This Service Information bulletin supersedes SI B11 11 12 dated November 2012.

NEW Recall Campaign 12V-550:: Replace Hex Bolt with Internal Thread for Deflection Pulley

E70 with M57Y engine

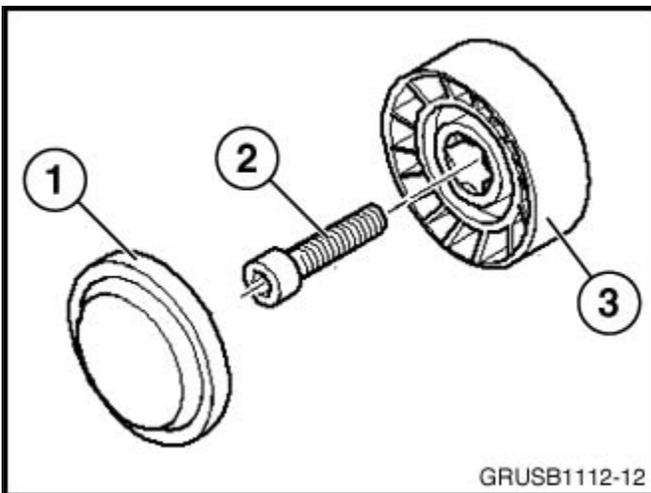
1. Replace the alternator and deflection pulley mounting bolt. Use repair instruction 12 31 020 “Removing and installing/replacing alternator (M57TU, M57T2)” to access the deflection pulley mounting bolt. Do not remove the alternator.
2. For better accessibility the fan cowl and the upper cross member have to be removed as per repair instruction 17 11 035 Removing and installing/replacing fan cowl with electric fan (M57T2). When reinstalling the cross member new bolts are required.

Overview:

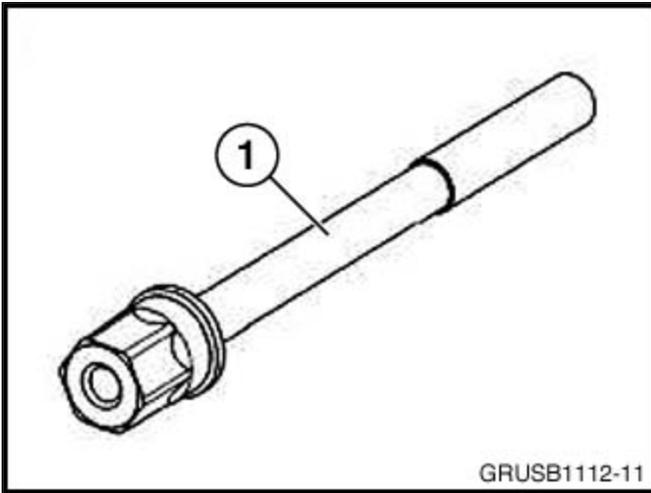
3. **NEW** Remove cover (1) from deflection pulley (2) to access the mounting bolt.

4. **NEW** Remove the deflection pulley mounting bolt (2) to remove the deflection pulley (3).

LABEL INSTRUCTIONS

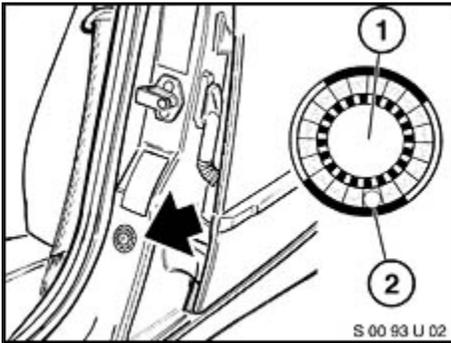
- A. Emboss your BMW center warranty number in the middle of the label (1);
- B. Punch out code number **632** (2), printed on the label; and
- C. Affix the label to the B-pillar as shown.
